Addendum No. 1

Date: October 25, 2017
City Project: 14-25, "East Monte Vista Avenue Rehabilitation"

12. Sheet 21, TRAFFIC SIGNAL DETECTOR LOOP PLAN

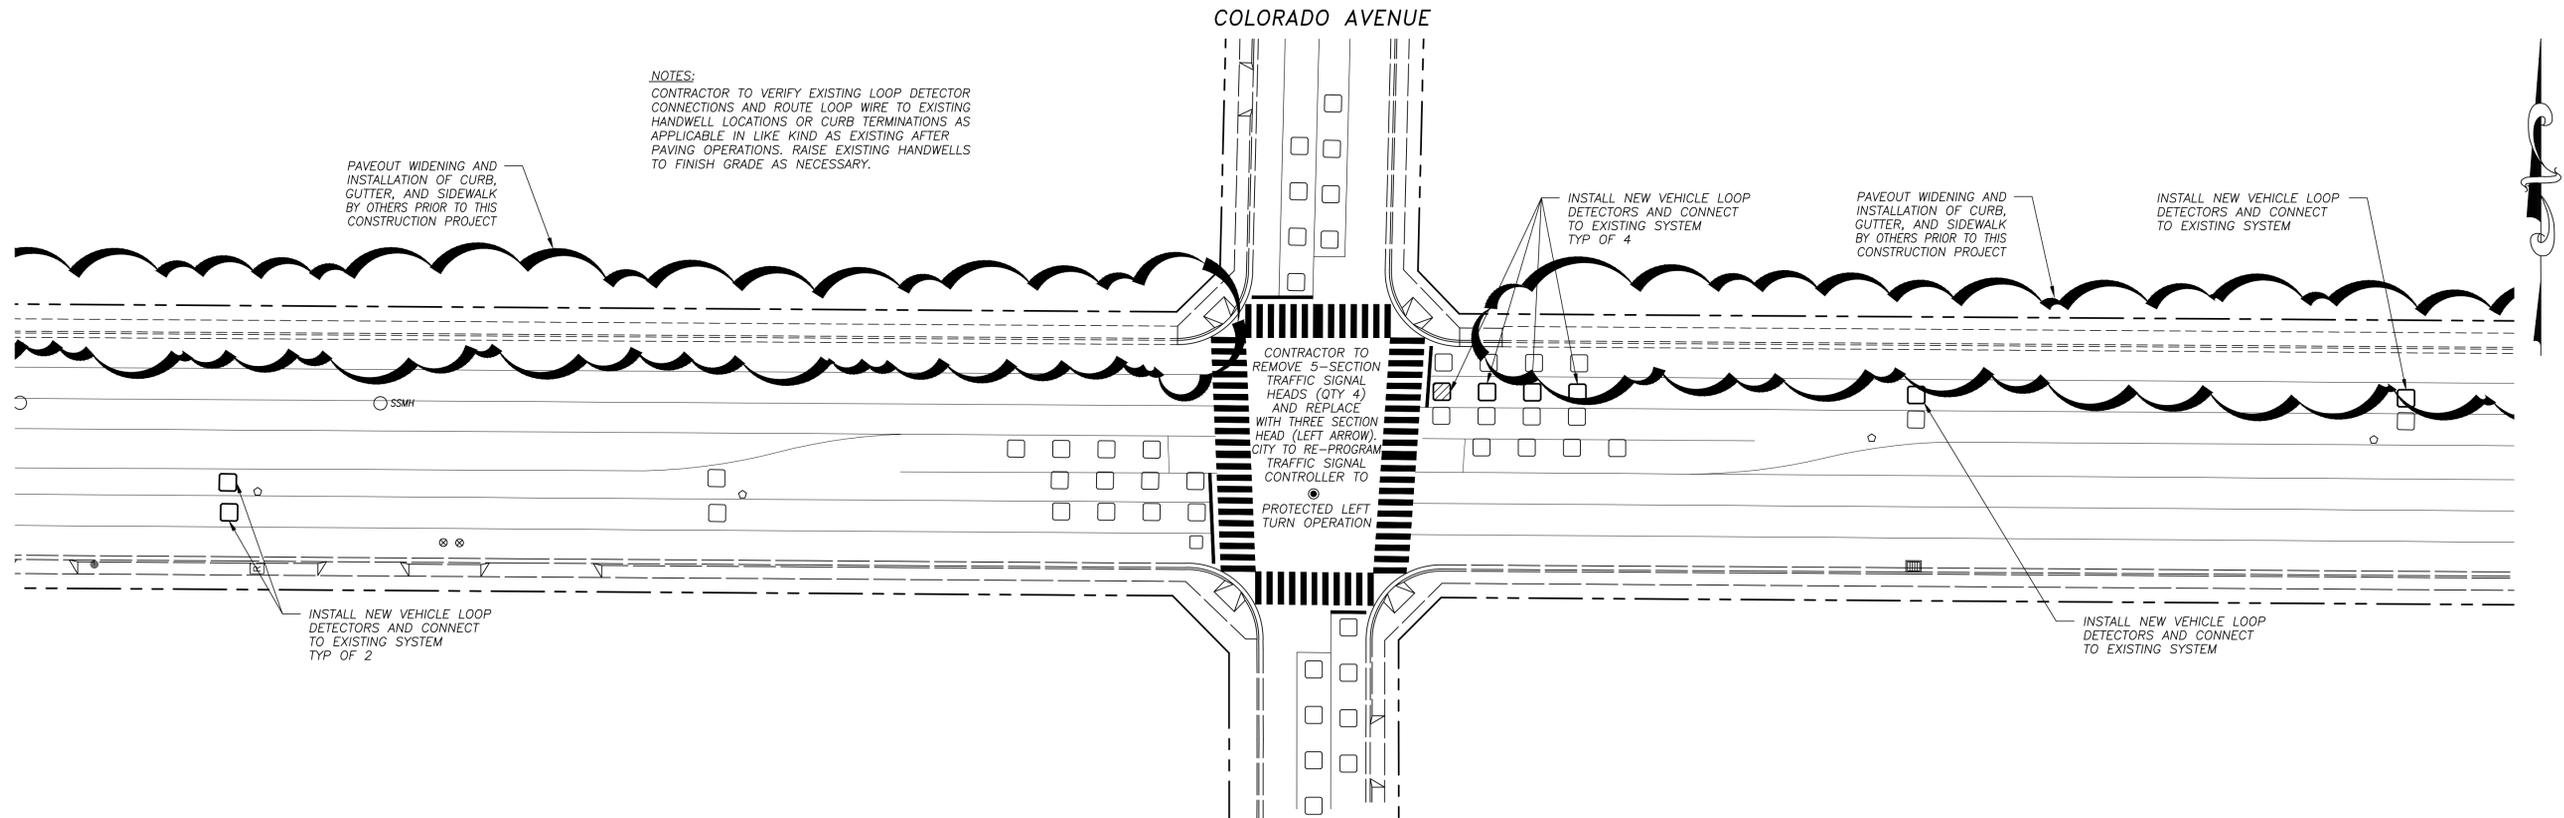
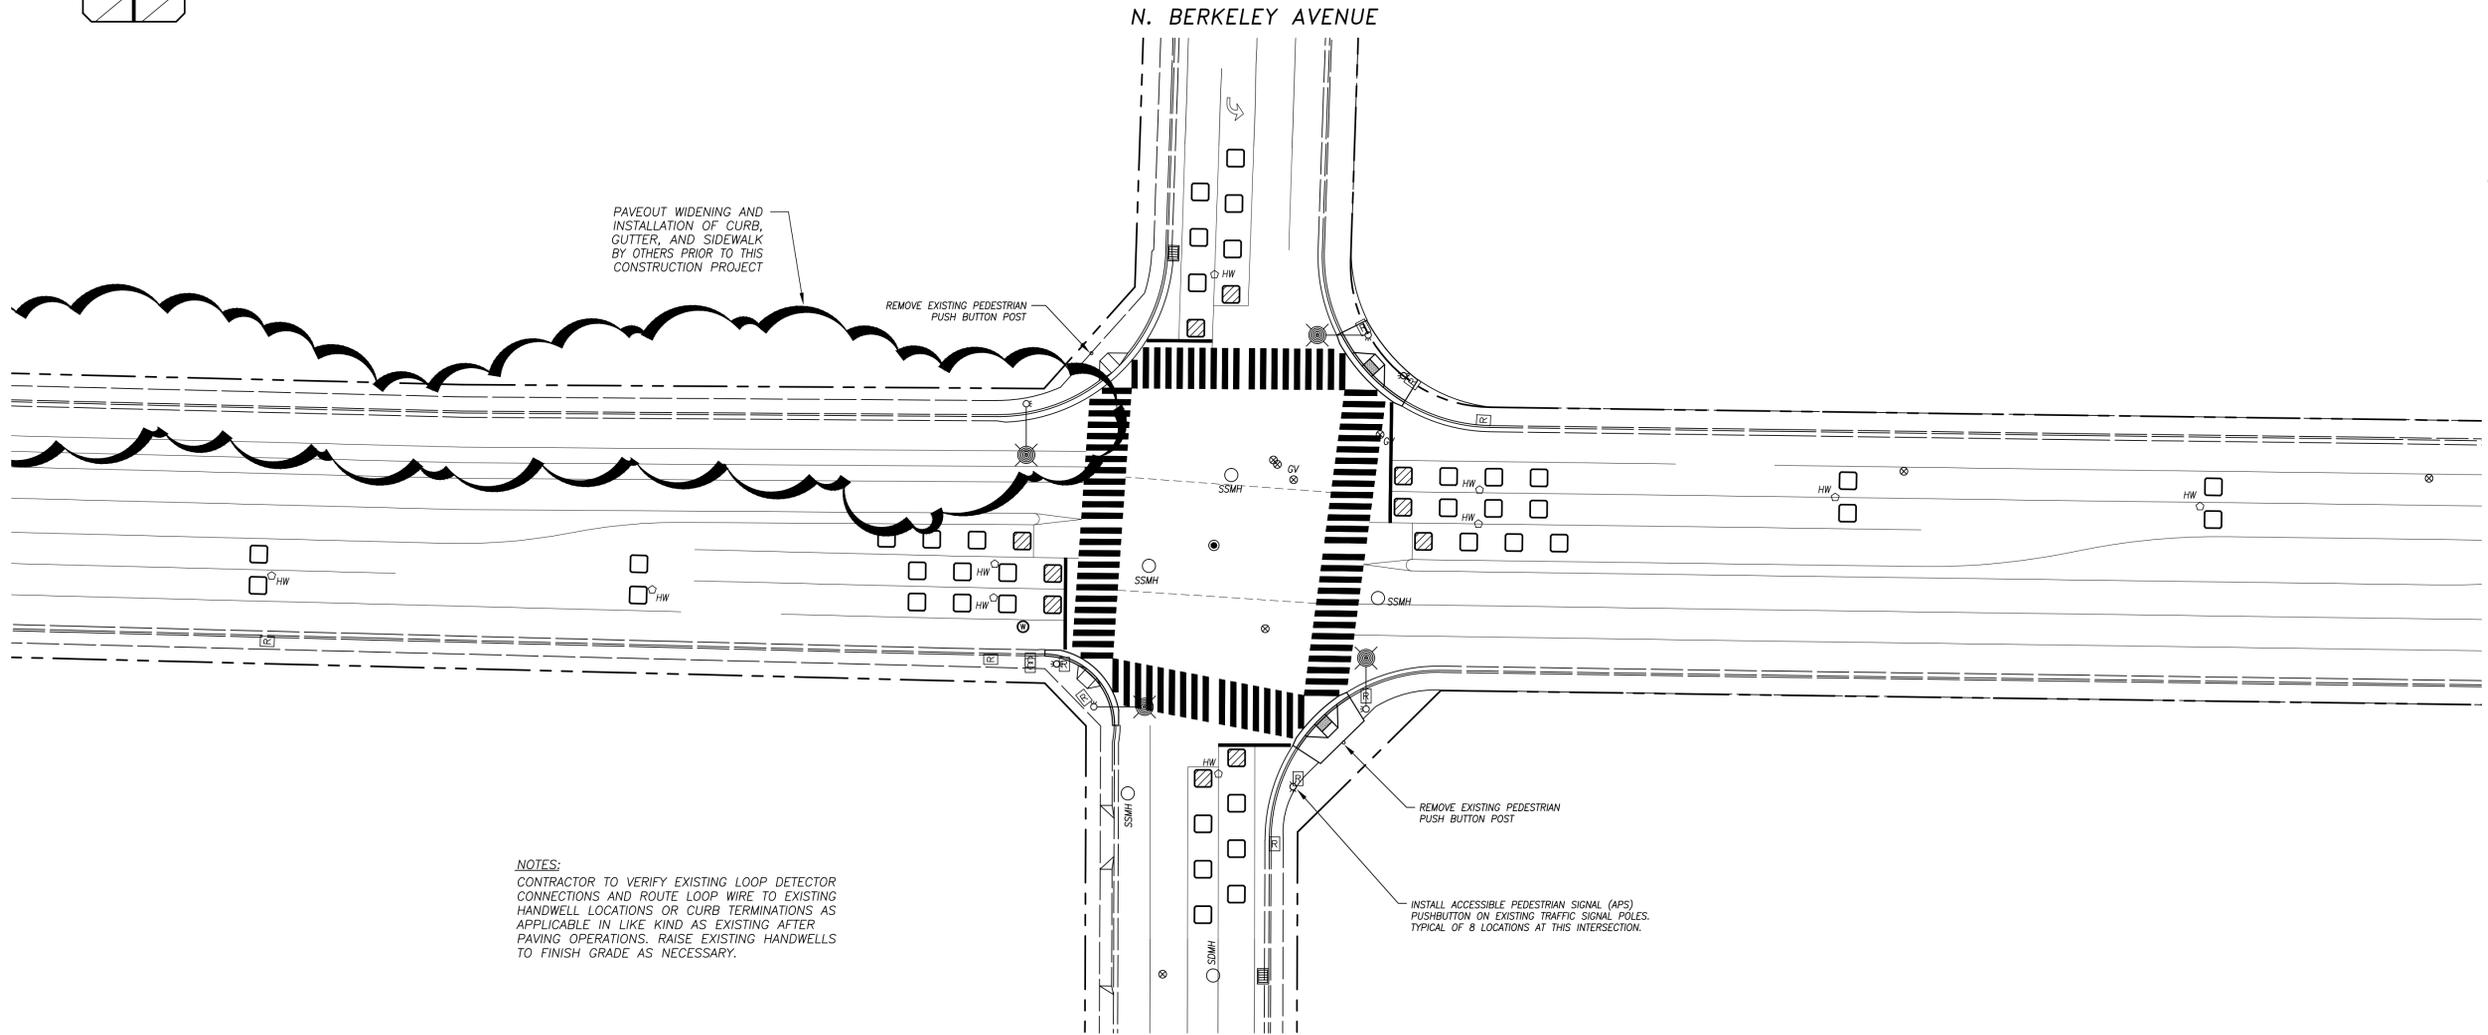
Q1: What is the scope of bid item no. 19, "Traffic Signal Modification (protected left turns)"?

A1: Notes have been added to Sheets 20 and 21 issued with this addendum to add notes to the plans to direct the contractor to remove and replace 5-section traffic signal heads with 3-section heads (left arrow) at the intersections of Monte Vista Avenue/Colorado Avenue and Monte Vista Avenue/Berkeley Avenue.
